Economic Commission for Europe**Inland Transport Committee****World Forum for Harmonization of Vehicle Regulations****Working Party on Passive Safety****Sixty-sixth session**

UN Regulation No. 44 (Child Restraint Systems)**Proposal for Supplement 18 to the 04 series of amendments
to UN Regulation No. 44 (Child Restraint Systems)****Submitted by the expert from the European Commission ***

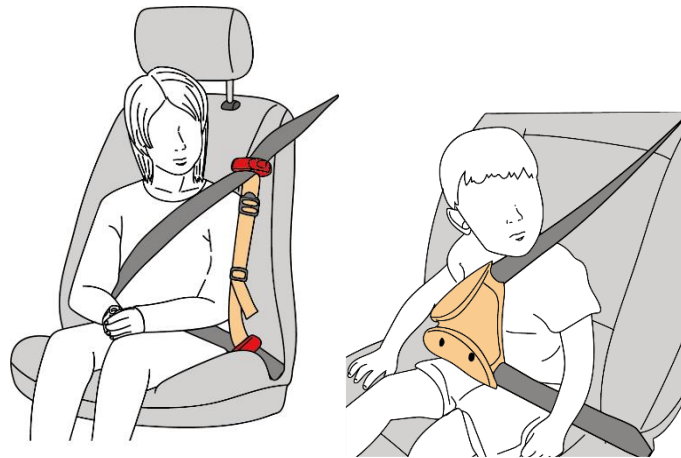
"1.2. **This Regulation explicitly forbids child restraint systems in the form of belt guides and other sitting devices that are dangerous and can harm children in the event of a vehicle collision, irrespective of any test results obtained in accordance with paragraph 8.**

In particular, it concerns belt guides and sitting devices meant for children of a mass from 15 kg to 36 kg that connect to or attach onto the lap belt portion as well as the torso belt portion of a 3-point adult safety belt system with the aim to alter the adult safety belt routing by for example pulling down the torso belt portion or squeezing together the torso belt portion and lap belt portion. Examples of such non-compliant devices are shown below.
